CONSTRUCTION PLANS
FOR
**PONDEROSA AT
LORSON RANCH FILING NO. 3**
STREET/STORM SEWER AND UTILITY CONSTRUCTION PLANS

COVER SHEET
STREET/STORM SEWER
AND UTILITY PLANS

PUDSP-19-010

DATE: APR 8, 2020
PROJECT NO. 100.050
SHEET NUMBER **C4.2**
TOTAL SHEETS: 30

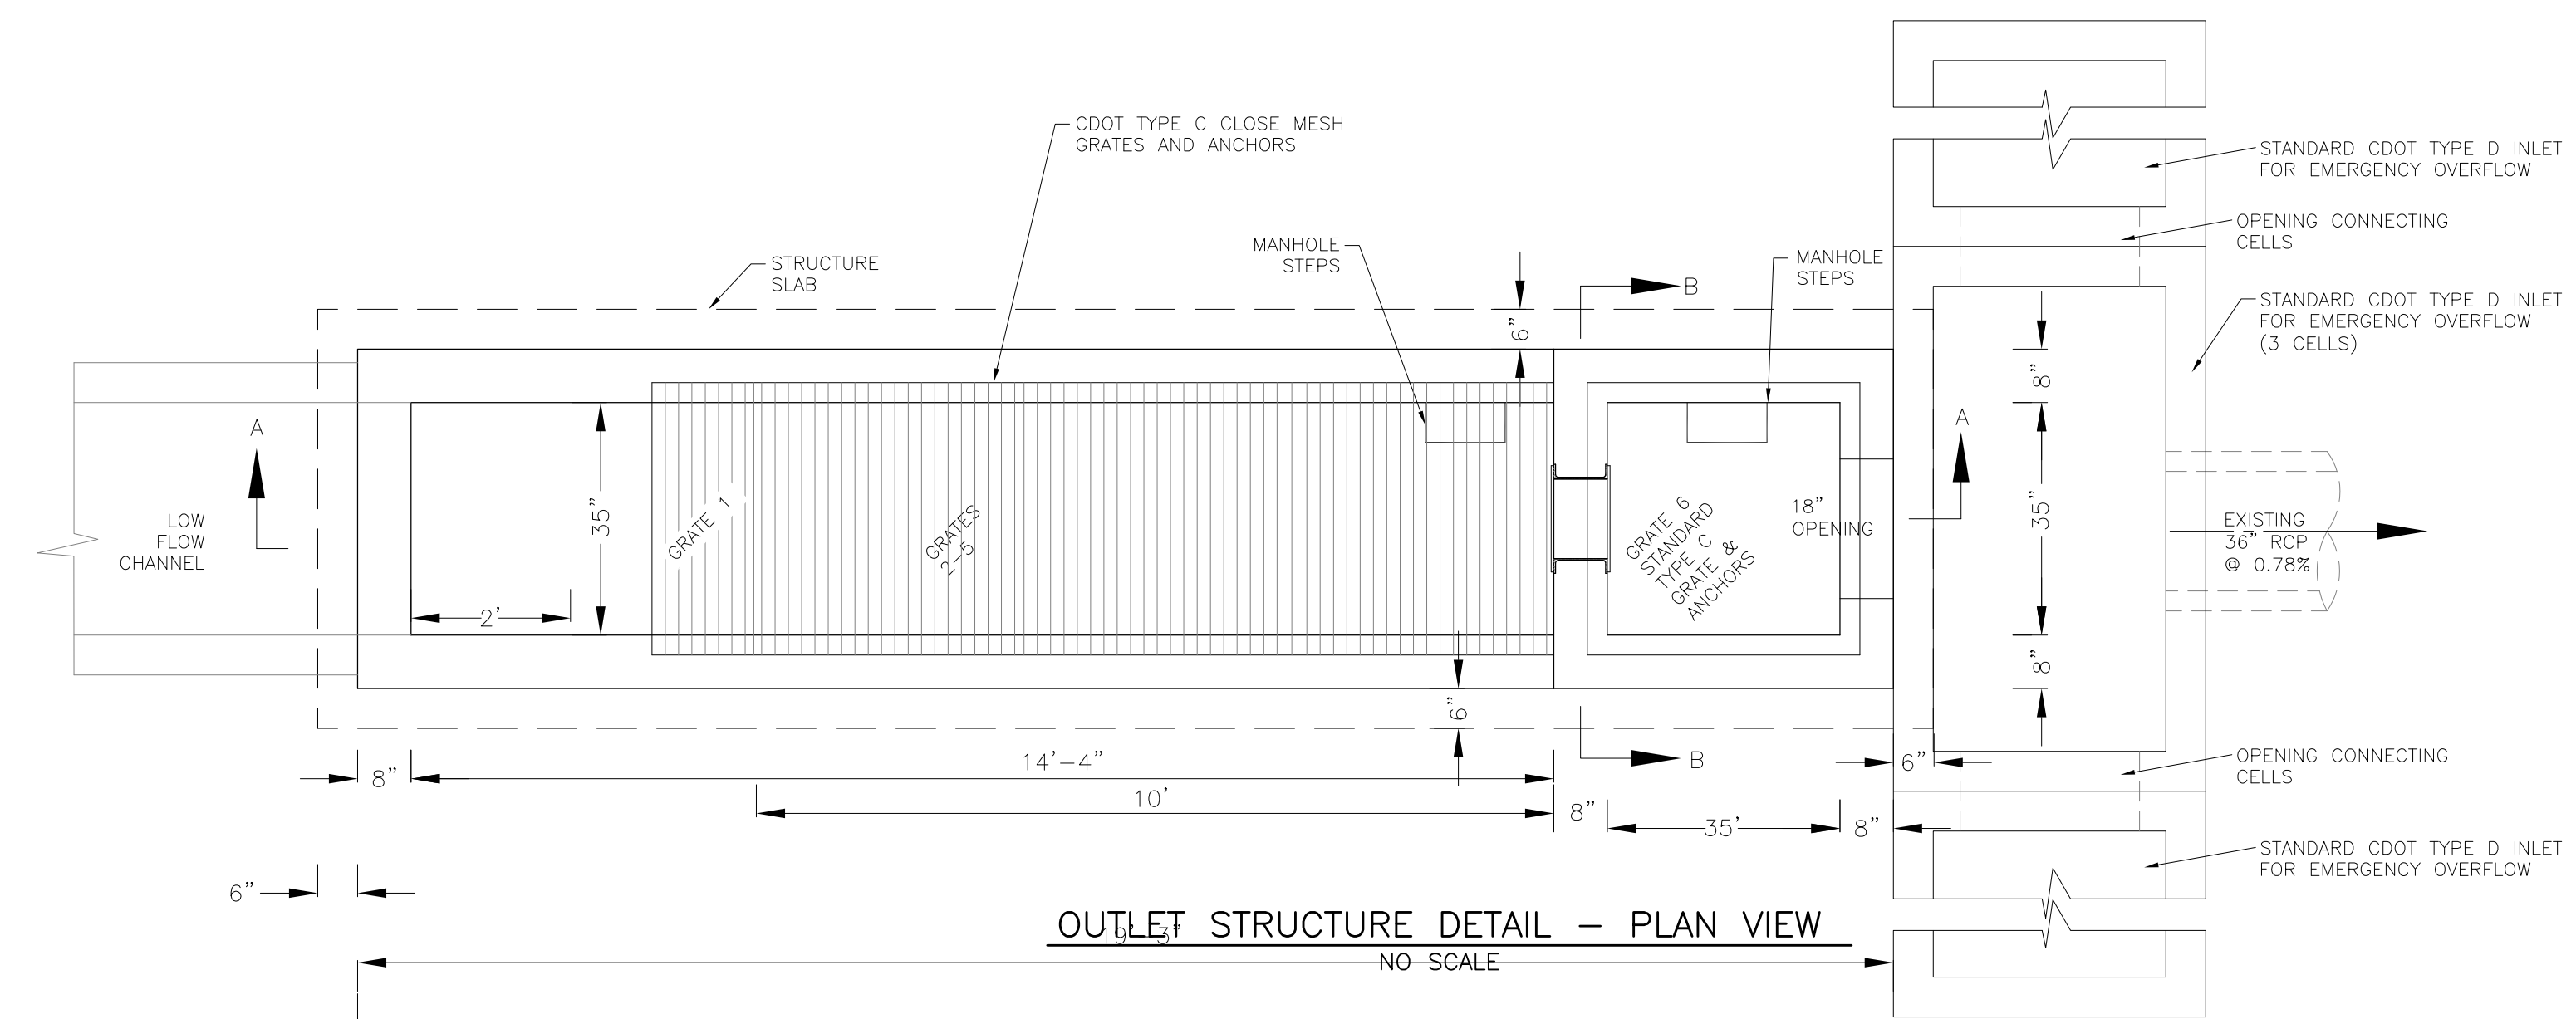
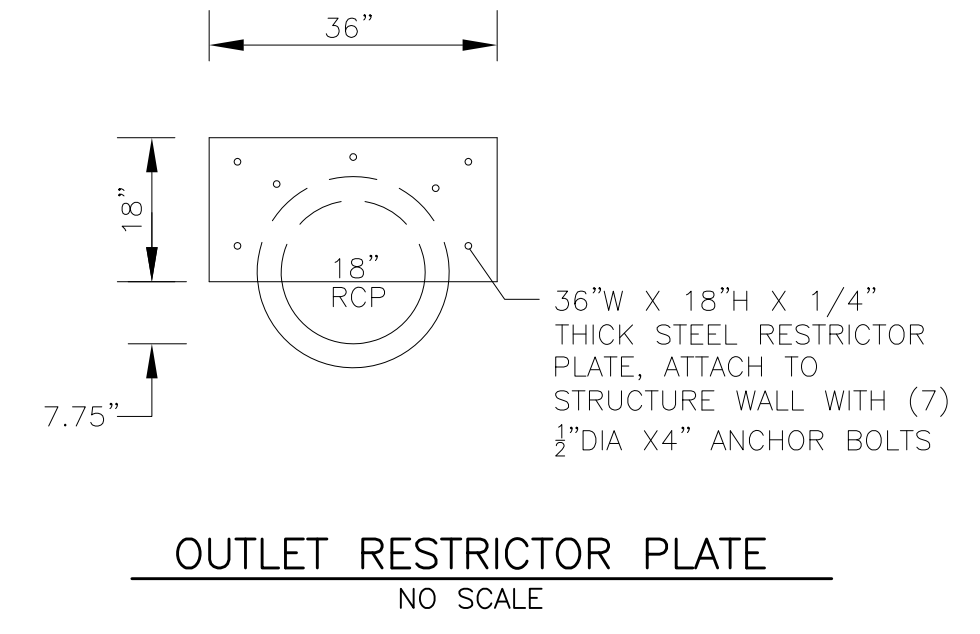
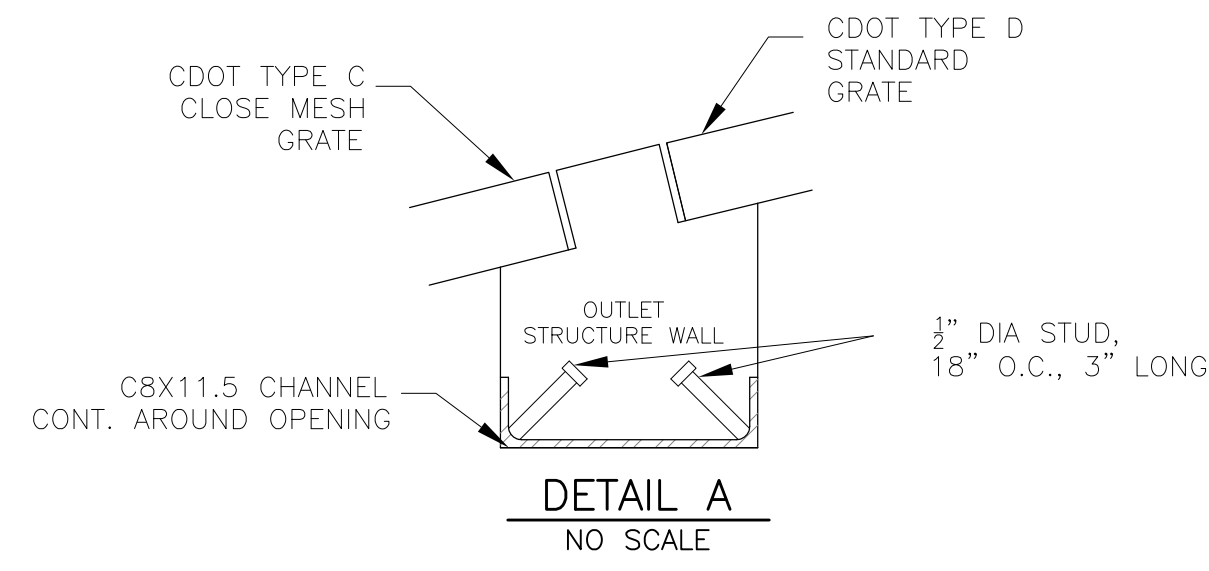
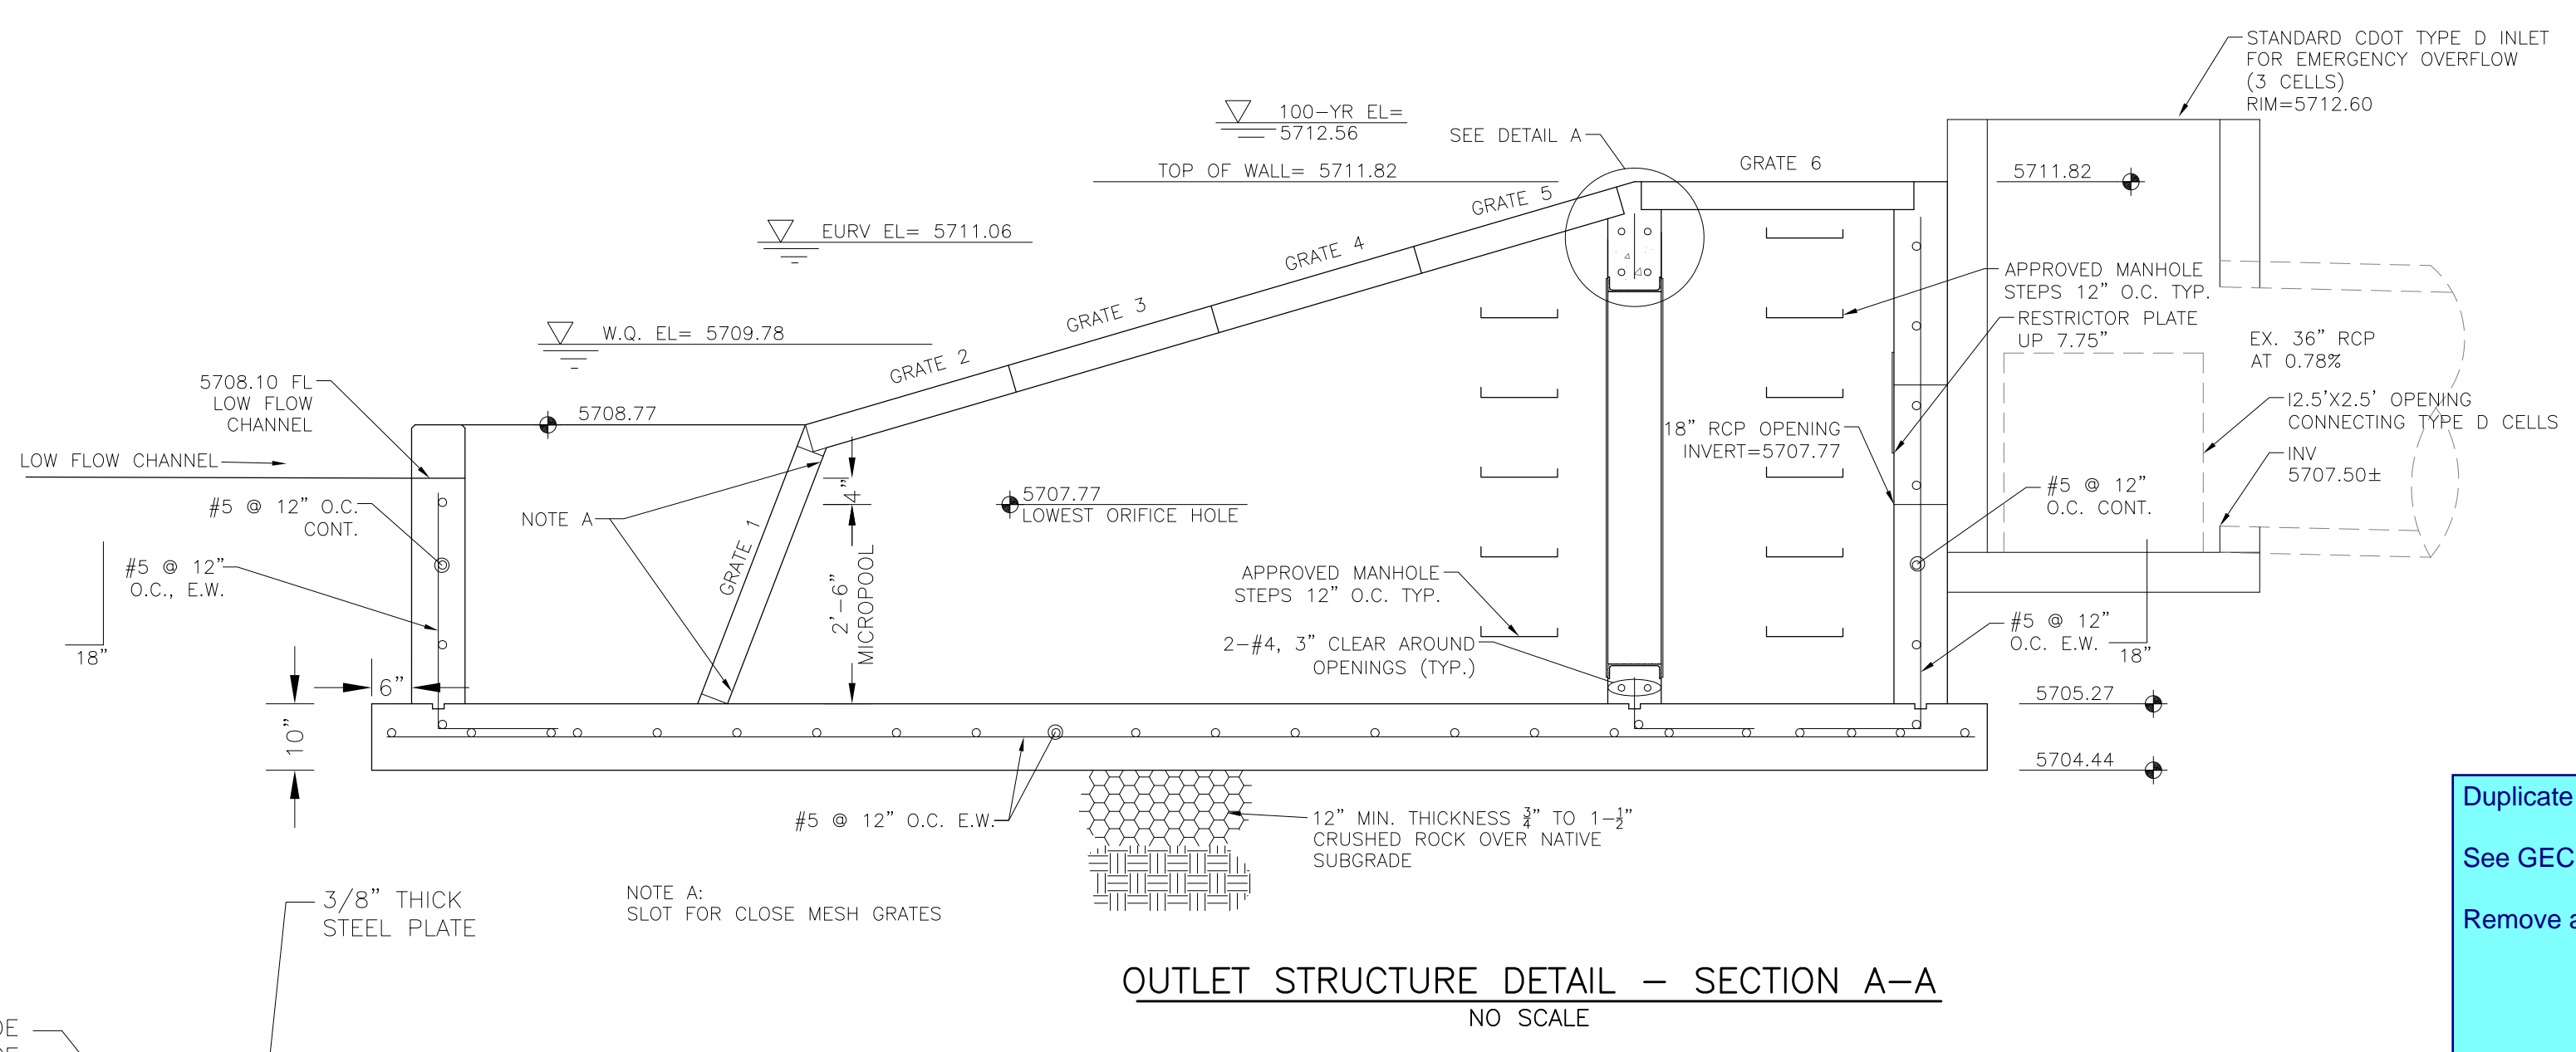
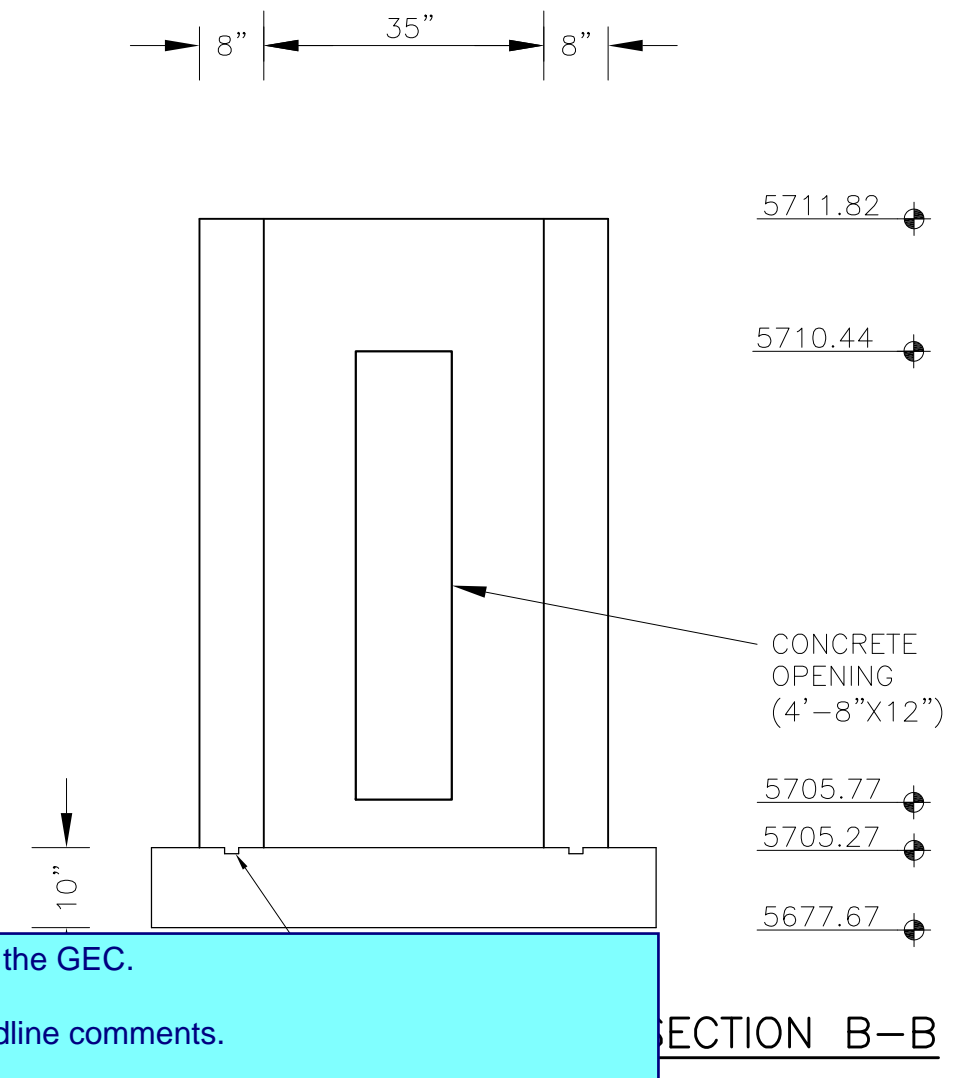
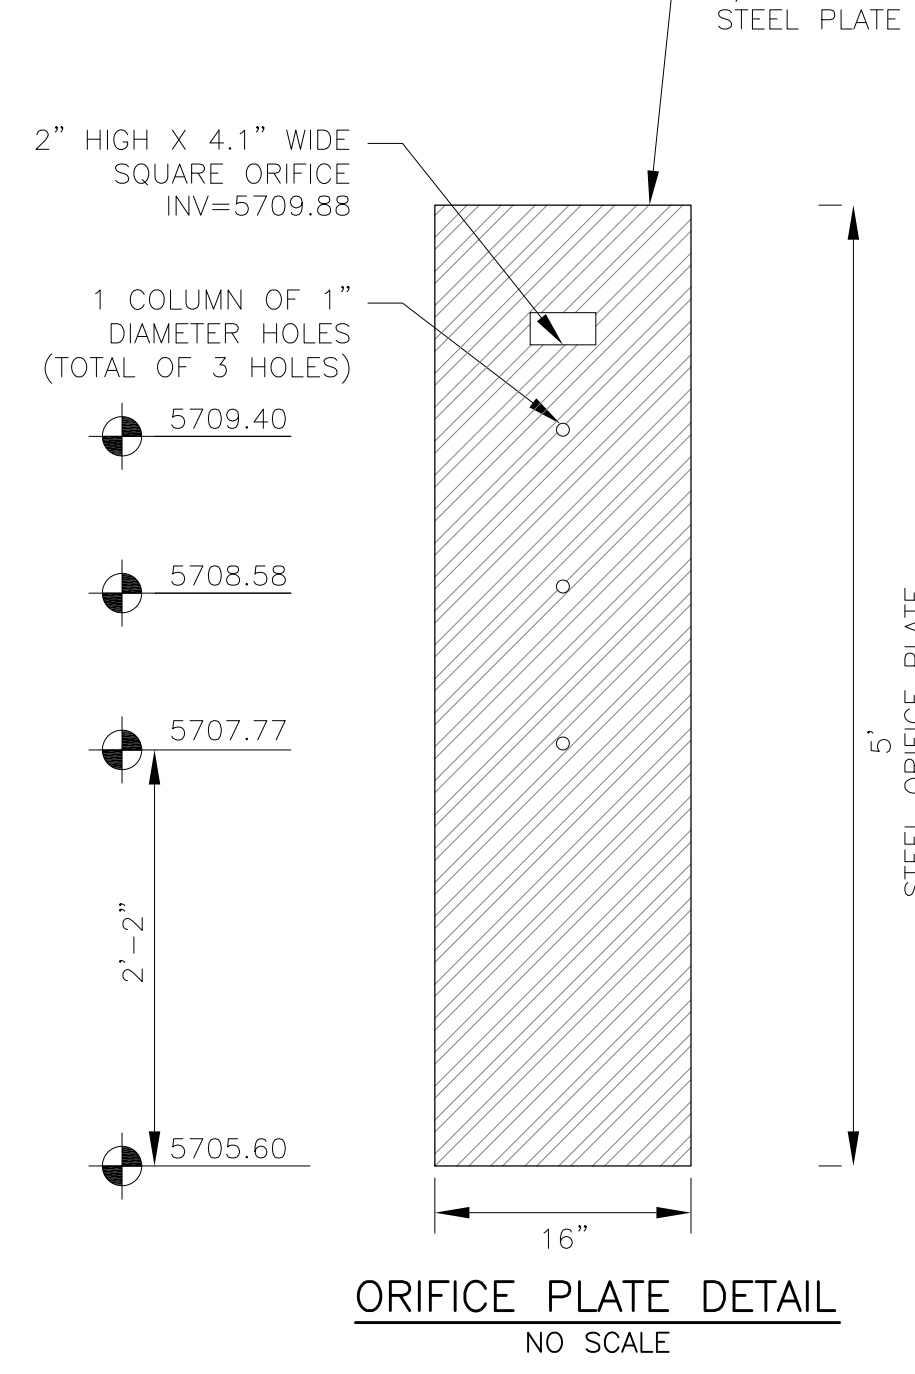
Duplicate sheet from the GEC.
See GEC Plan for redline comments.
Remove all duplicate sheets.
